Docket Item # 1
BAR CASE # 2011-0097

BAR Meeting
May 25, 2011

ISSUE: Flue extension

LOCATION: 624 North Patrick Street

Figure 2 Existing conditions at 624 and 626 North Patrick Street.

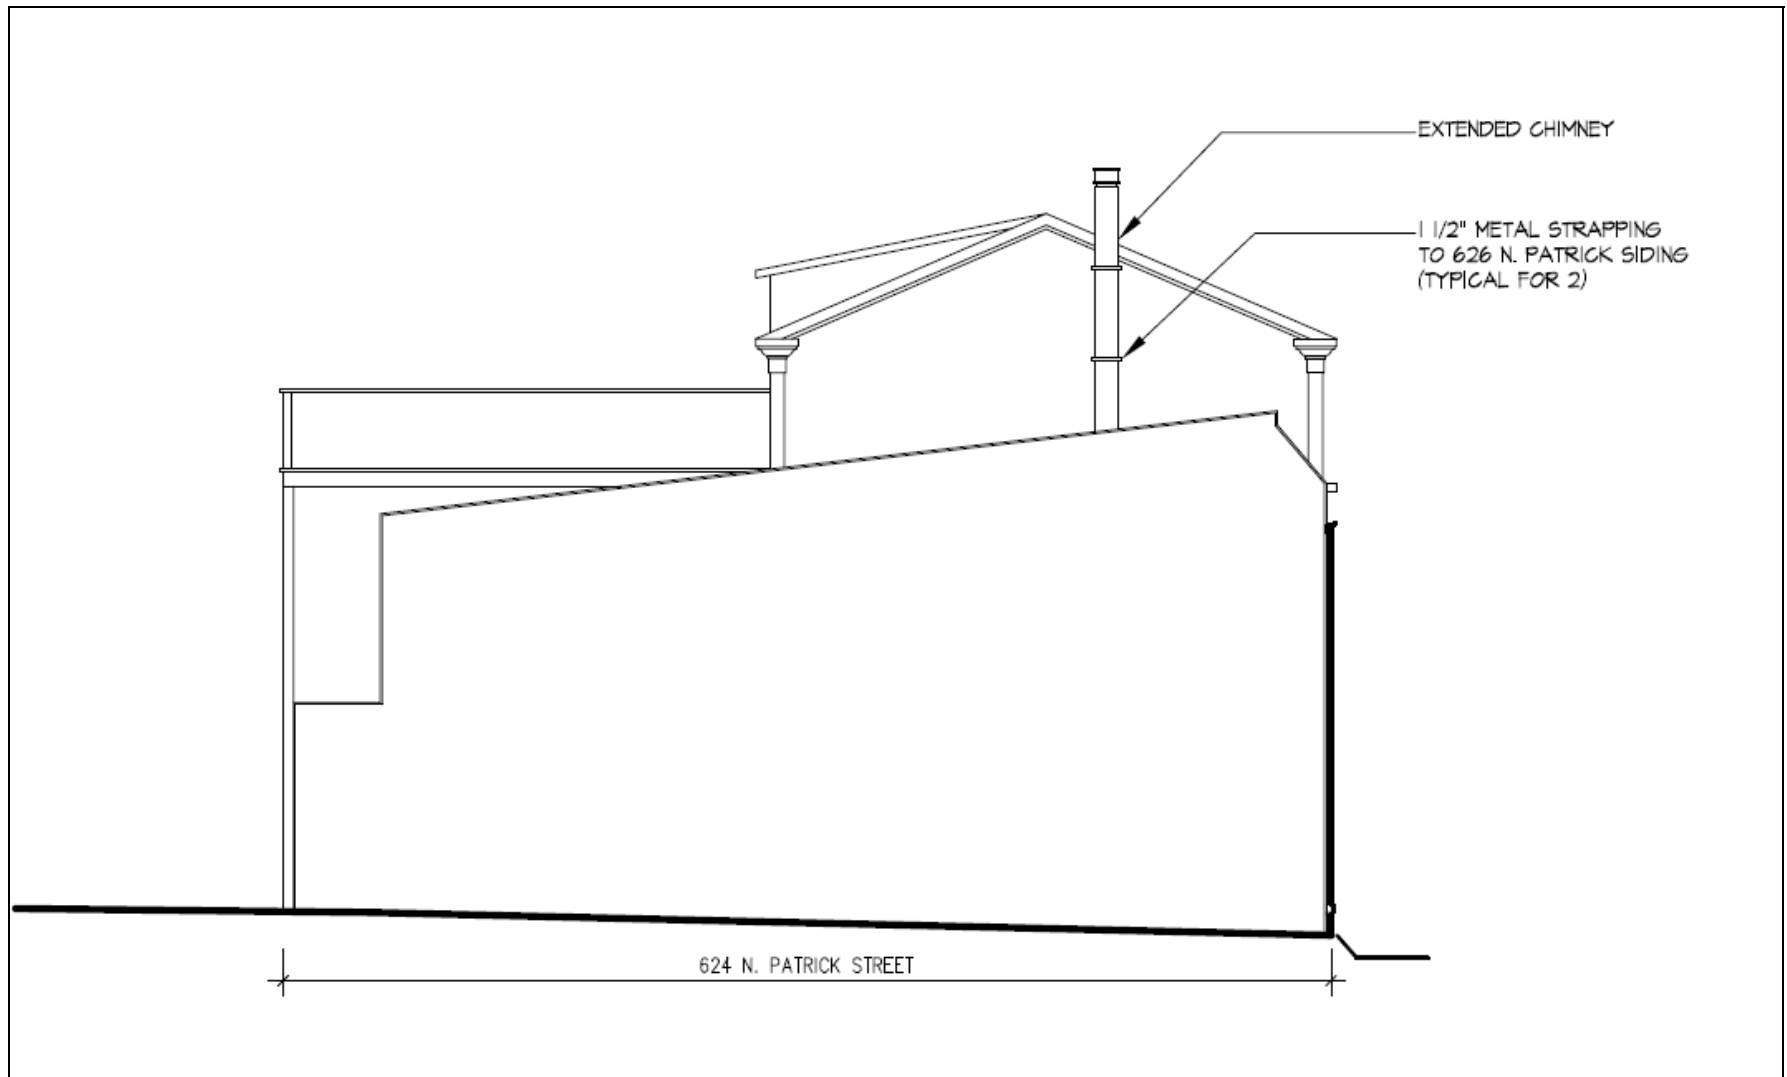
This application is the direct result of a condition created by the construction of a new townhouse on a vacant lot at the adjacent property, 626 North Patrick Street (BAR Case #2010-0129). As the new townhouse was constructed on the property line and is taller than the existing house at 624 North Patrick Street, the wood burning fireplace metal chimney flue of 624 must be extended to meet building and fire code regulations. The building code requires that a flue must extend a minimum of 24 inches above any building or portion thereof within ten feet of the flue. The flue at 624 North Patrick Street was an existing condition that existed well before the construction at 626 North Patrick Street and was not previously visible from the street.
